SIB 51 11 22

DELIVERY STOP: REWORK THE RETAINING BRACKETS FOR THE SPINDLE DRIVE

E-Series	Model Description	Production Date
G01	X3 Sports Activity Vehicle (SAV)	May 17, 2022

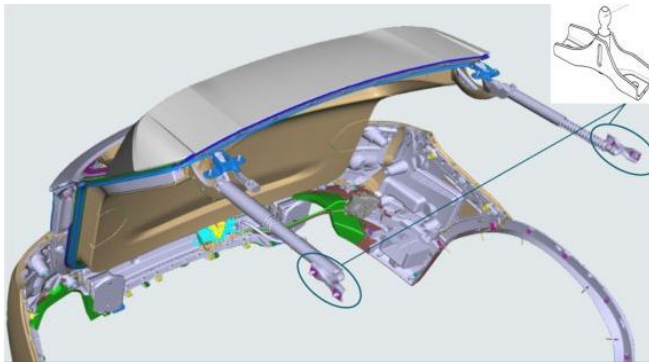
BMW AG has issued a Delivery Stop (effective June 3, 2022) on 11 (eleven) Model Year 2022 BMW X3 SAV vehicles that were produced on May 17, 2022.

The bolts for the spindle drive retaining brackets were tightened to an incorrect torque.

Tighten the spindle drive retaining brackets to 28 Nm of torque.

Following repair instructions **51 24 351 "Removing and installing/replacing right electrical spindle drive for tailgate"** tighten the spindle drive retaining brackets to 28 Nm.
